City of Tualatin

ARCHITECTURAL REVIEW FINDINGS AND DECISION

**** APPROVAL WITH CONDITIONS ****

Case #: AR-18-0001
Project: TVF&R Station 39
Location: Adjacent to 7100 SW McEwan Road
(Tax Lot: 2S113DD01601)
Applicant: Frank Angelo, 921 SW Washington Street, Suite 468, Portland, OR 97205
Project Contact: Same

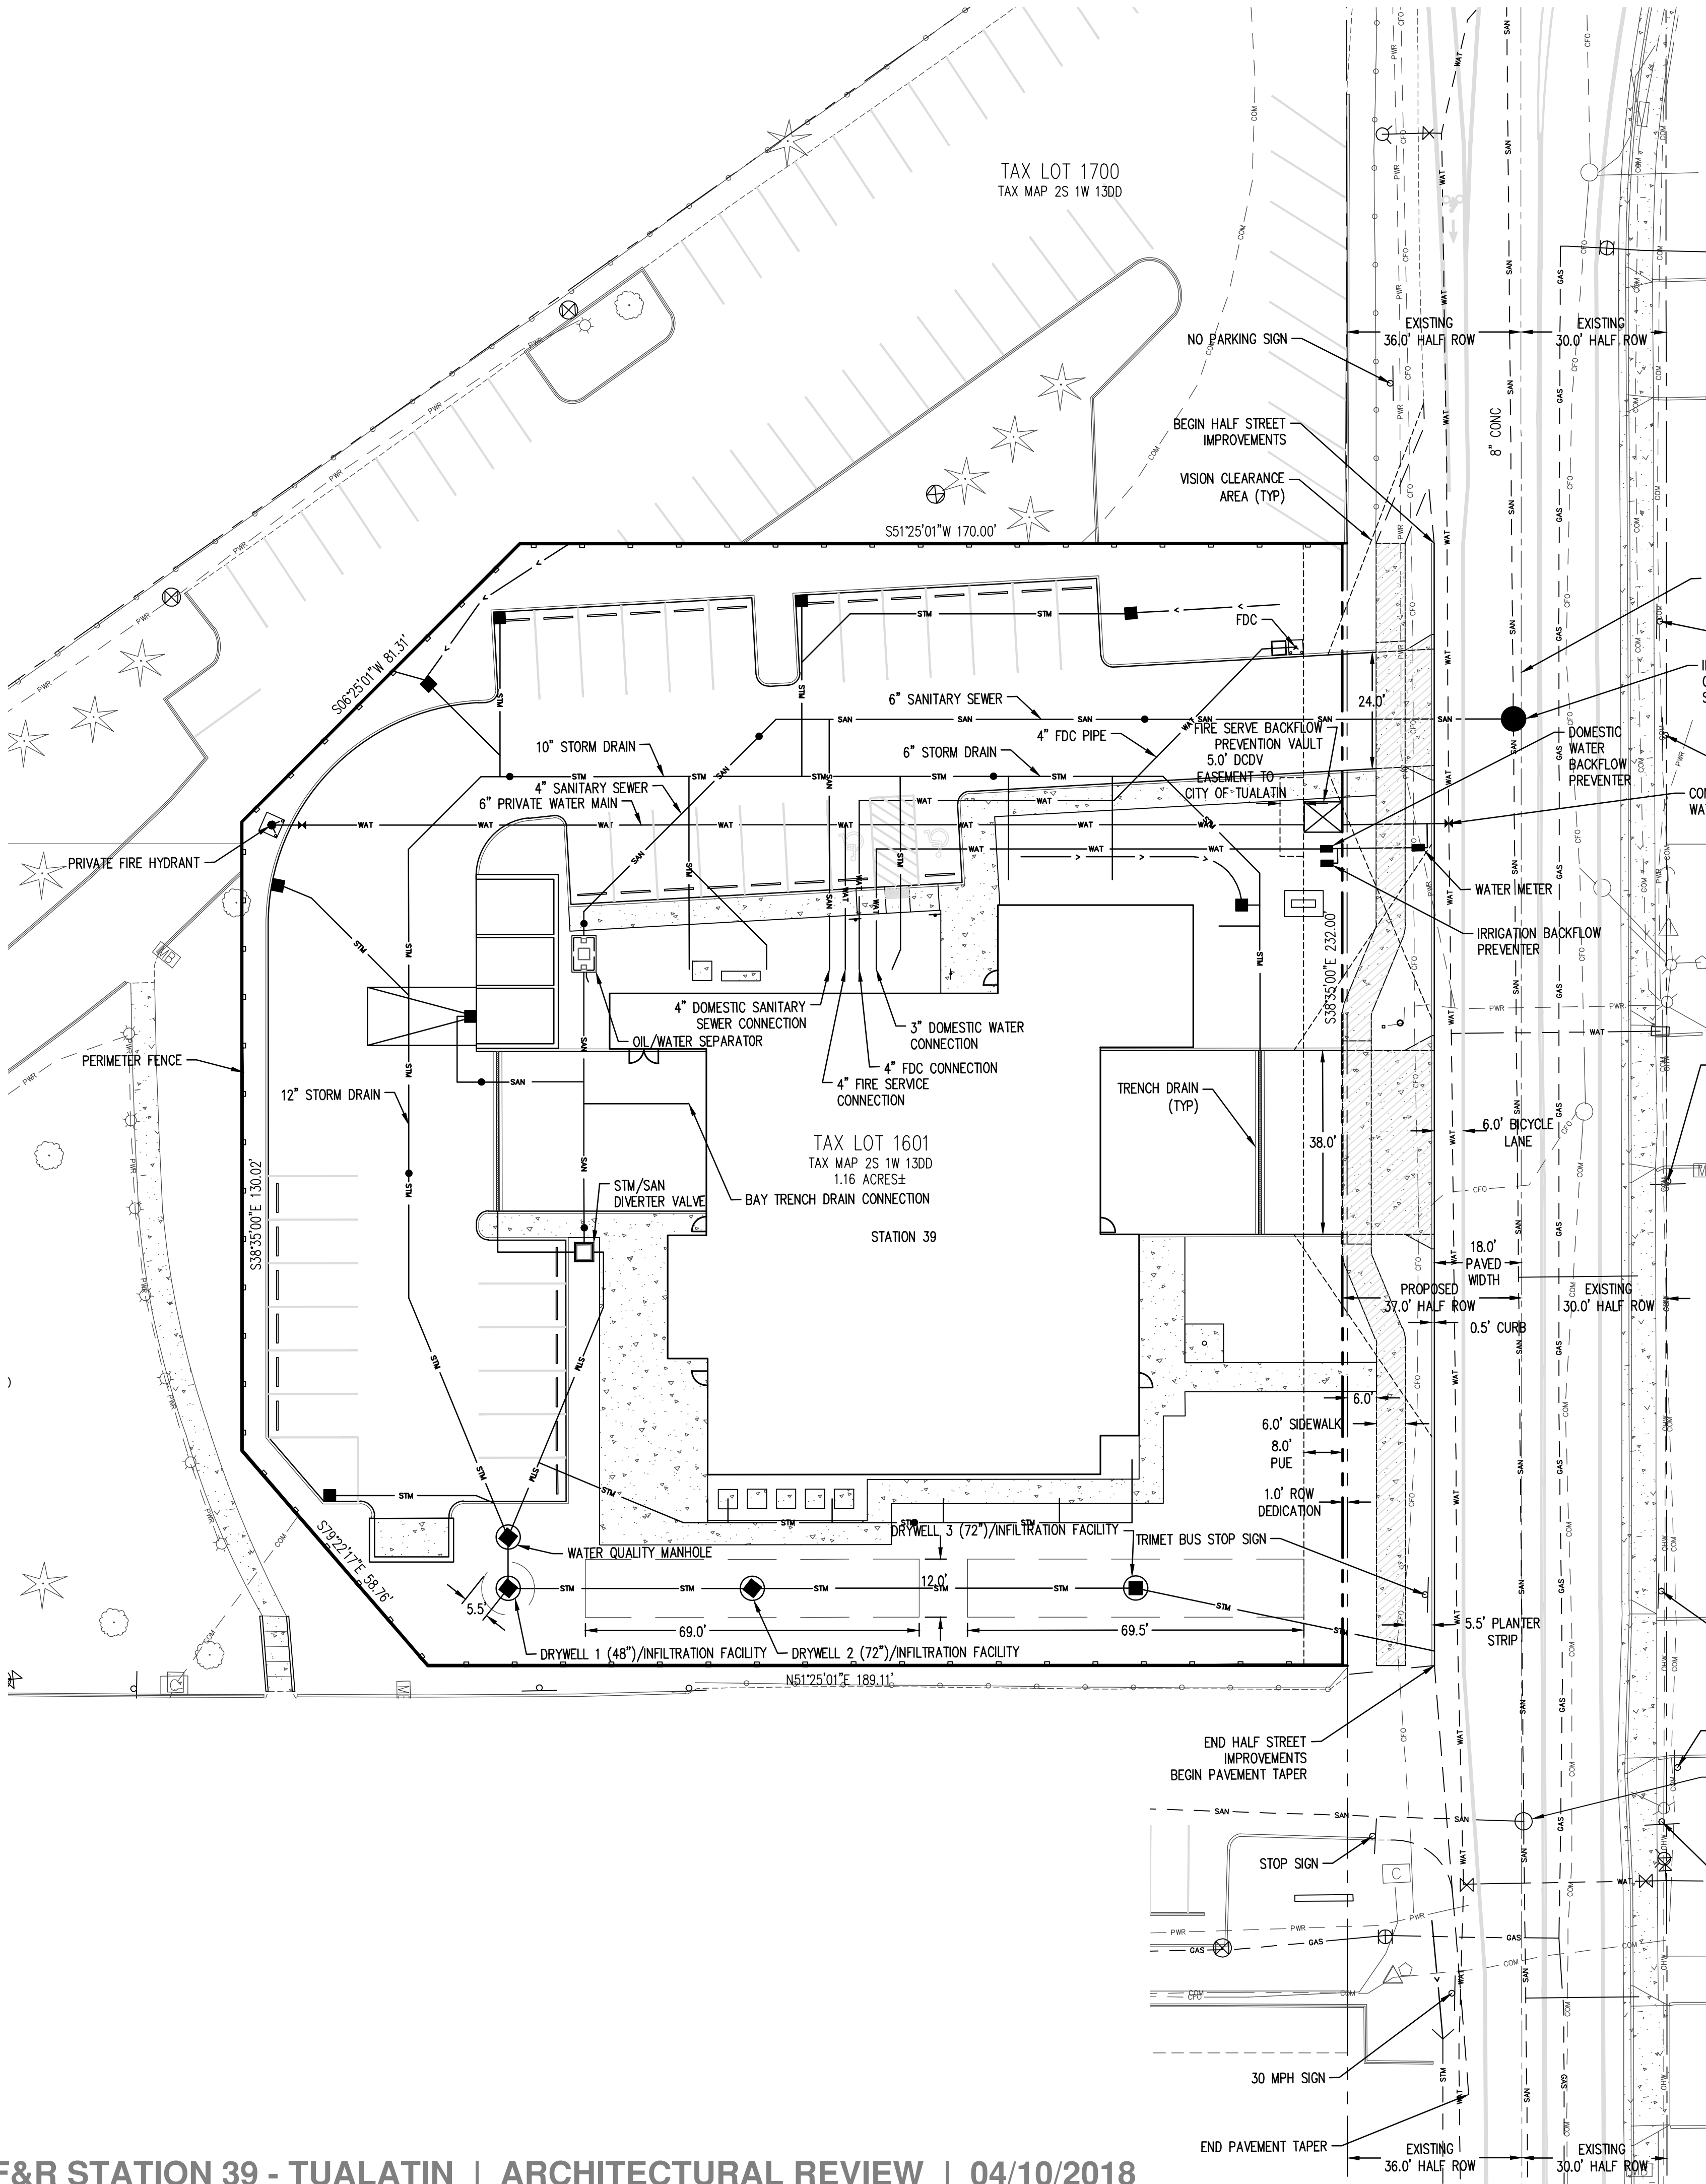
As explained in Section 1(a)(iv) above, staff finds that the project is required to include accessways, and that accessways are provided. However, the accessways shown on sheet C4 and the rest of the applicants submittal are only 6 feet wide for the southern accessway and 5 feet for the northern accessway. Because these qualify as accessways, they are required to be at least 8 feet wide. To assure compliance with this standard, a condition of approval has been added to require the exhibits to be modified.

The plans show on Sheet C4 a single connection for domestic and fire. Separate laterals are needed for each service with valves at the main. The final plans will include a separate lateral with a valve at the main for domestic and fire water services.

LANDSCAPE PLAN

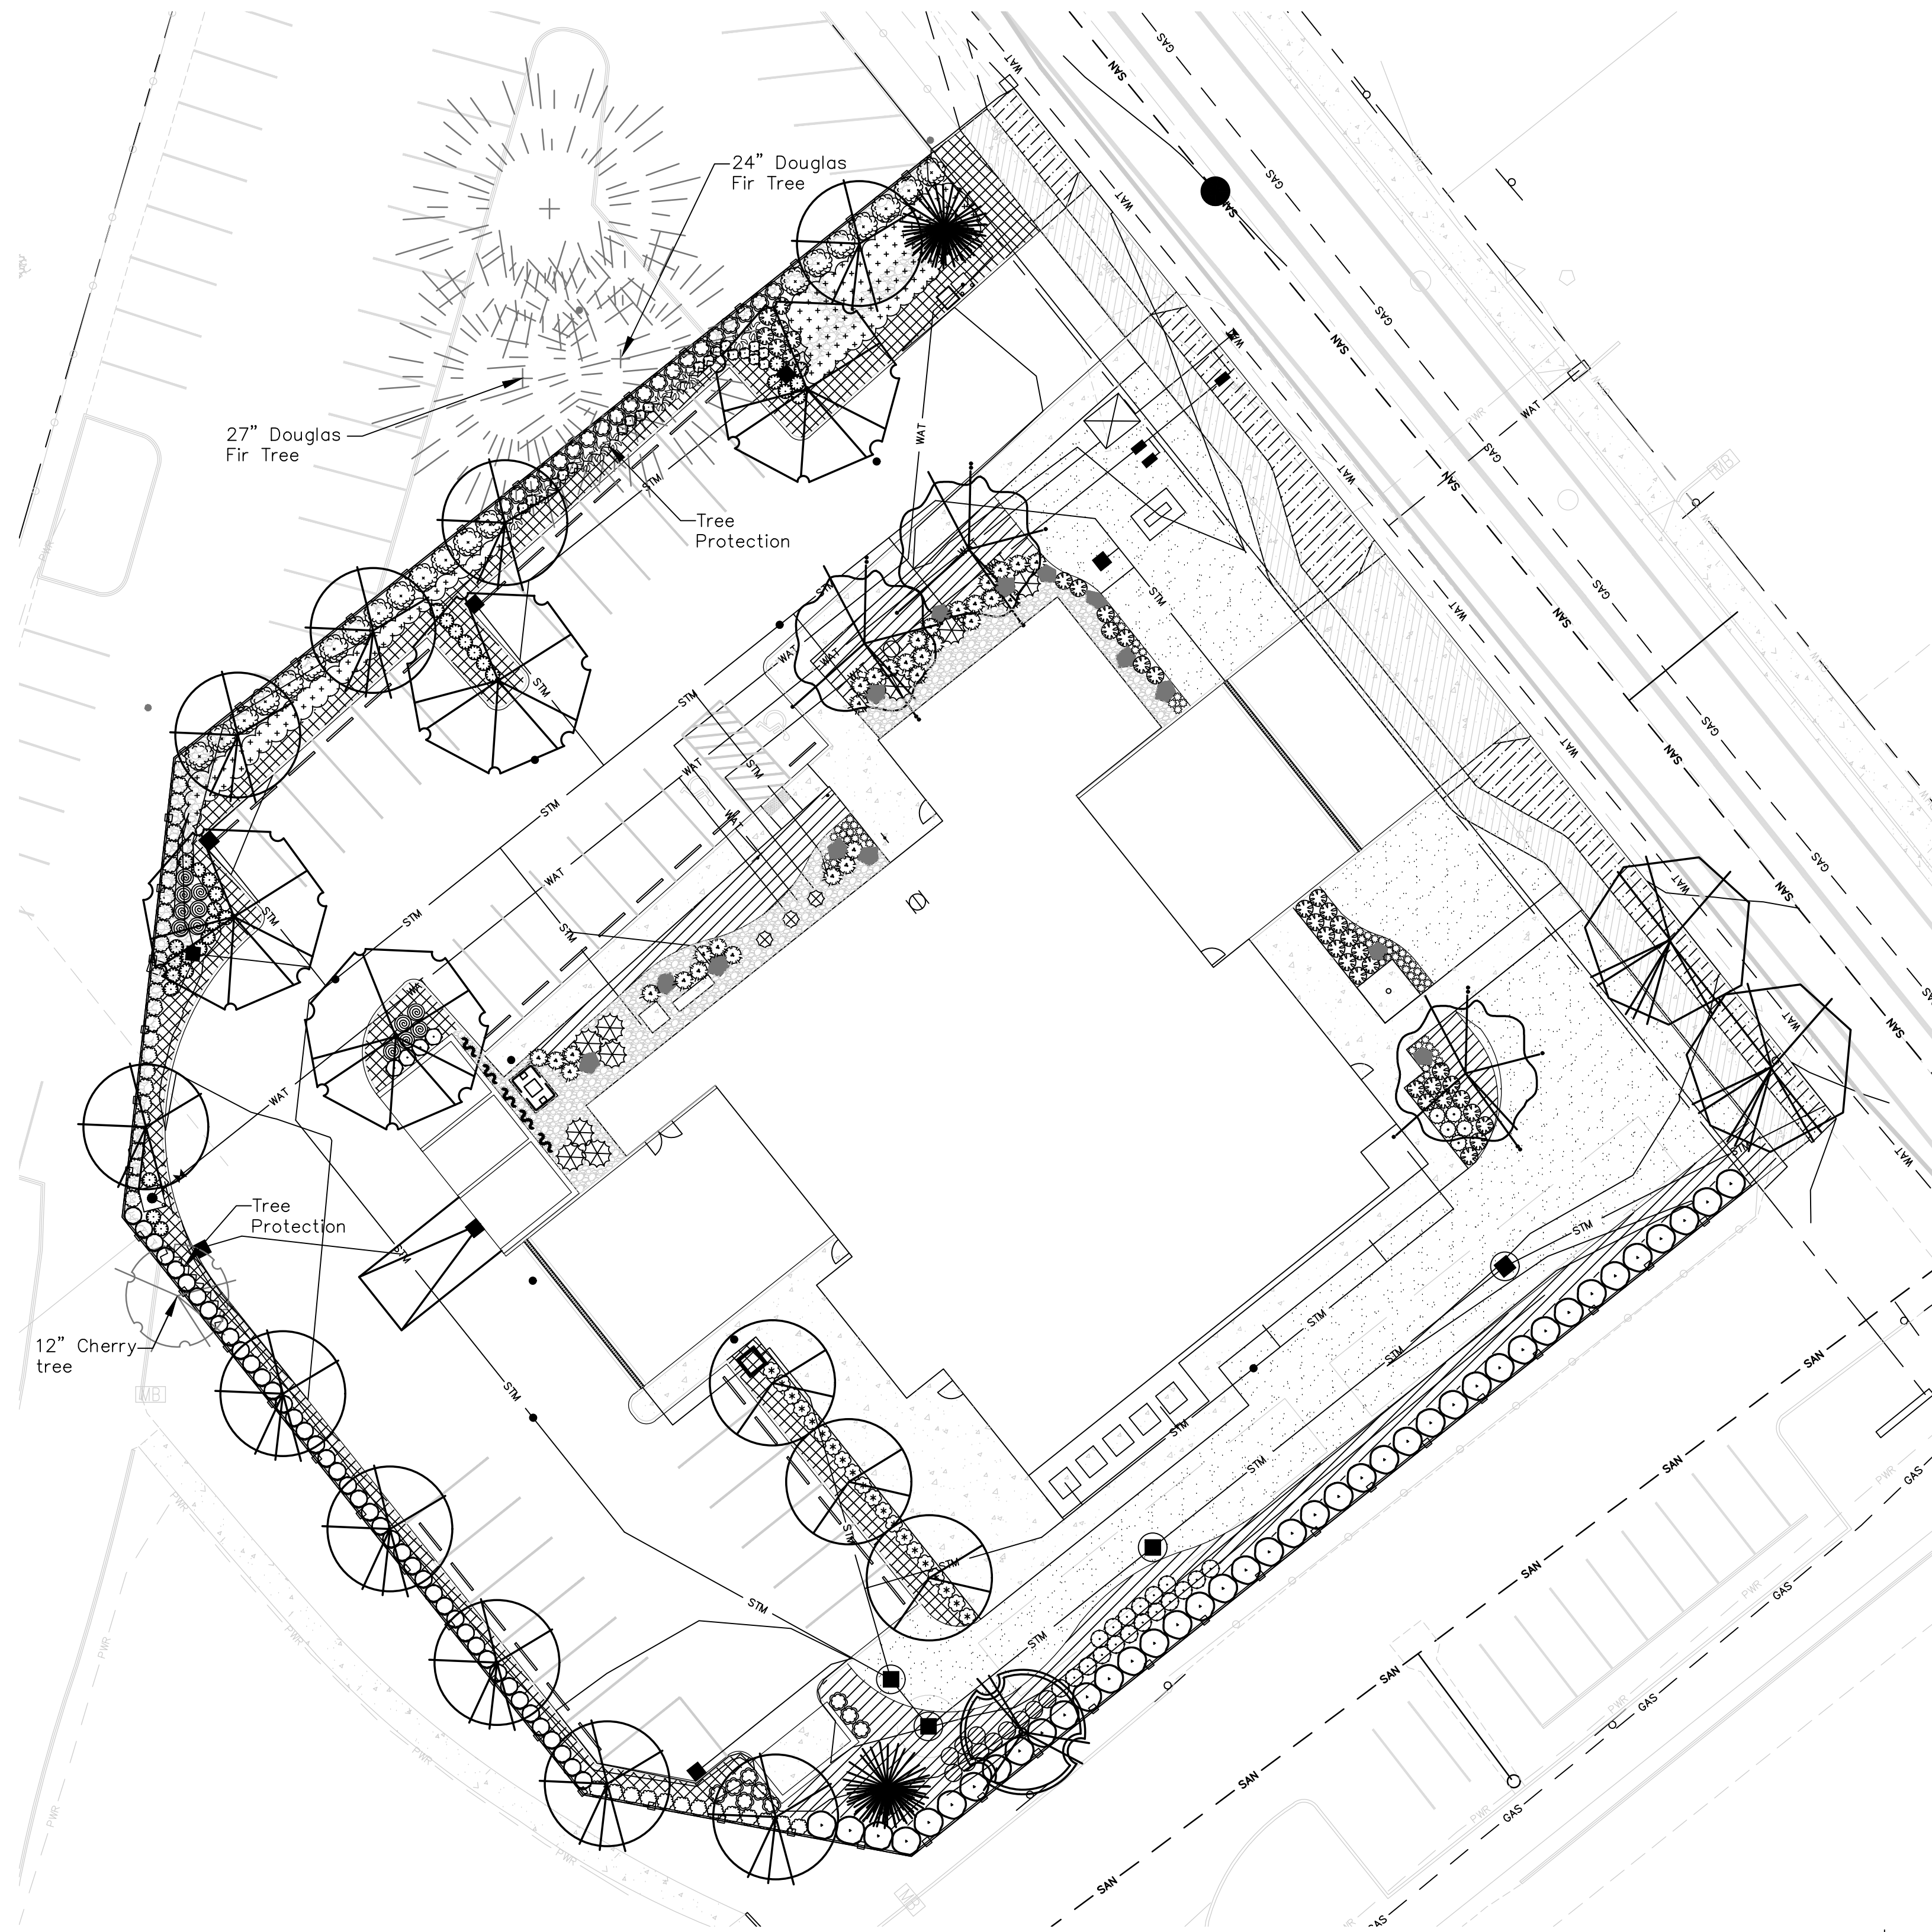
Staff notes the shrub height specification is included on the Landscape Plan (sheet L1.0, dated 4/10/18) as note number 4 and in the schedule. The tree height is not noted on the plans, however, the plans indicate that Paper Bark Maple, Eastern Redbuds, Raywood Ash, Shademaster Honeylocust, Sour Gum, Hogon Cedar, and Village Green Zelkava trees are proposed. All of these types of trees have typical heights well in excess of eight feet, with proper pruning the crown will satisfy this requirement. A note has been added under the conditions of approval that states landscaping must be continually

Staff notes that according to sheet L1.0, the development area is 54,680 sq ft and the applicant is proposing 18,004 sq ft of landscaping, which is 33% of the entire site. The site is not within the core area parking district and not subject to any fish or wildlife limitations. This standard is met.

Staff notes that sheet L1.0 shows wheel stops at all parking stalls. This standard has been met.

SHEET NUMBER
L2.0

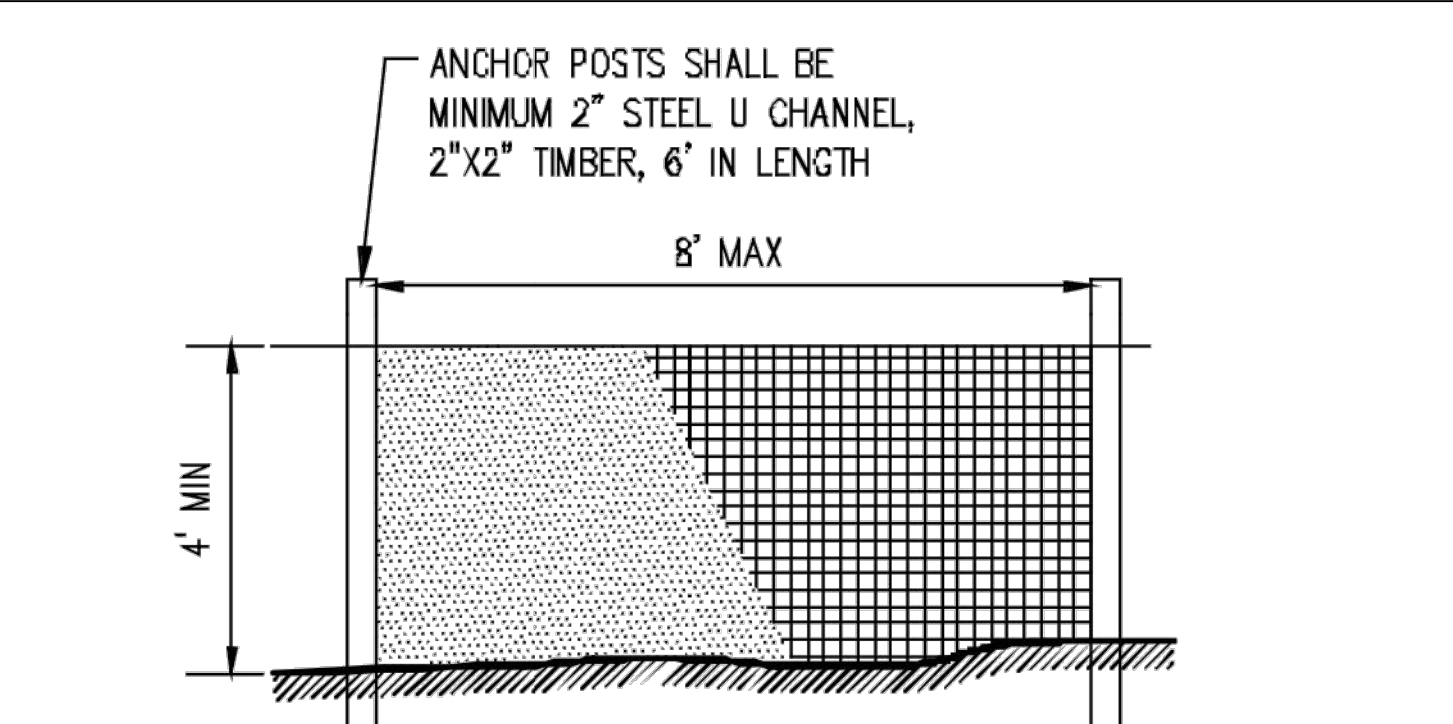
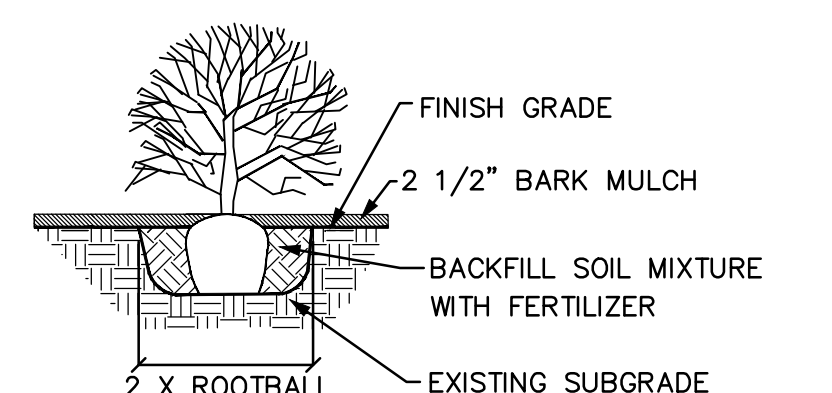
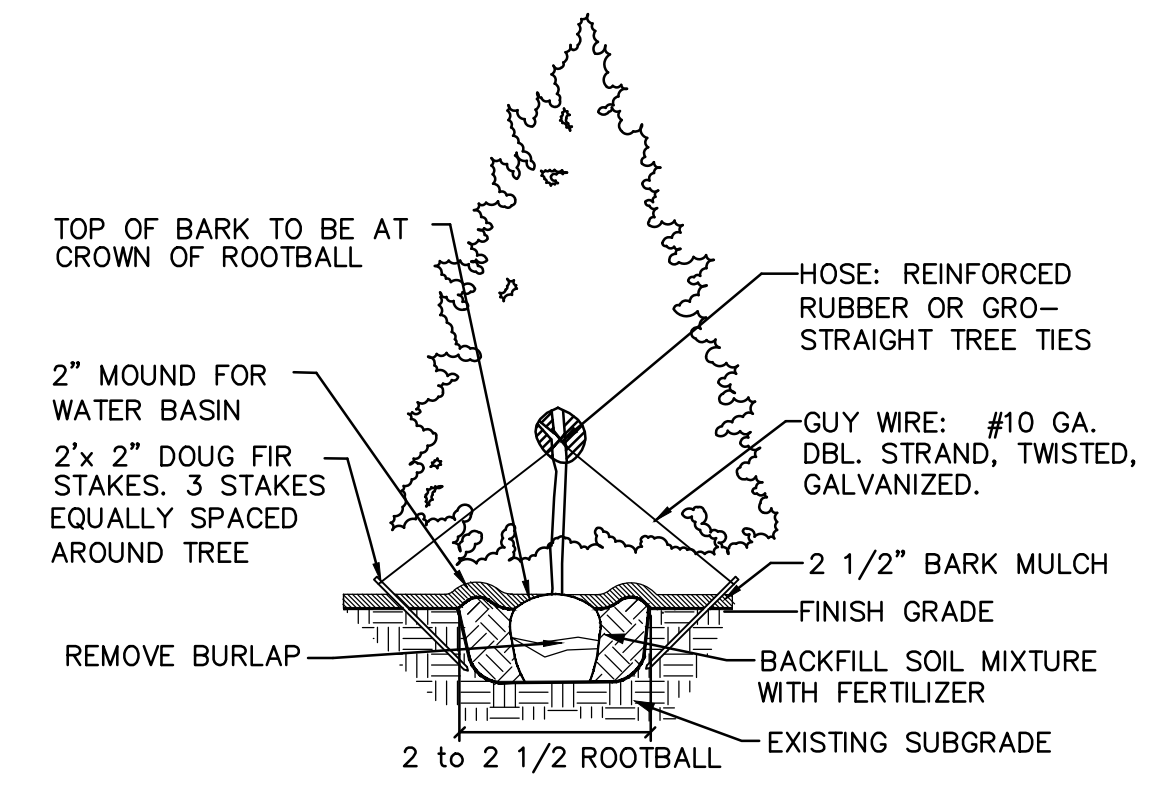
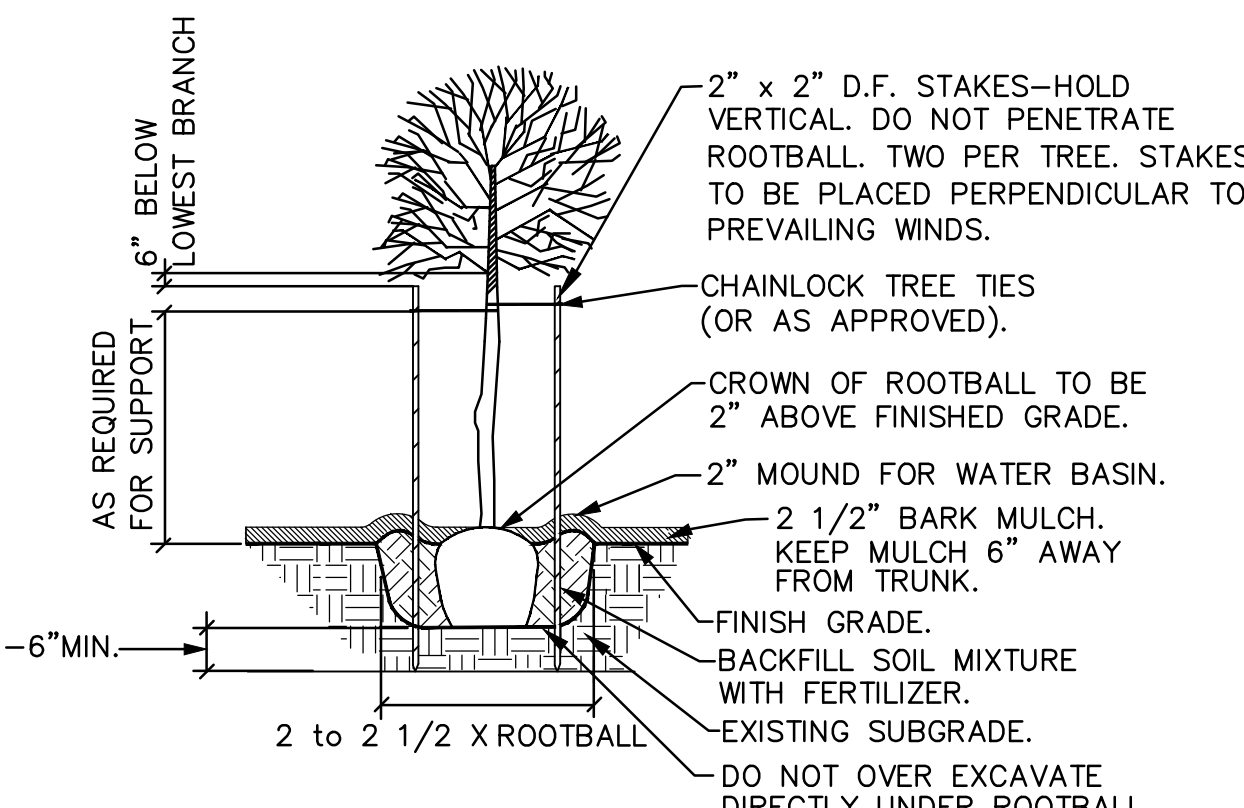
The Landscape Plans, sheets L1.0 and L2.0 demonstrate that with adequate maintenance, the ground will be covered in plantings within three years of planting. The notes on the plans explains that the landscape plans and the applicant are required to assure the standards from the code are maintained. This standard is met.

The Applicant is proposing 1.5" through 2" caliper trees that include Paper Bark Maple, Eastern Redbud, Raywood Ash, Shademaster Honeylocust, Sour Gum, Hogan Cedar, and Village Green Zelkova. Details on sheet L2.0 show full compliance with these requirements. This requirement has been met.
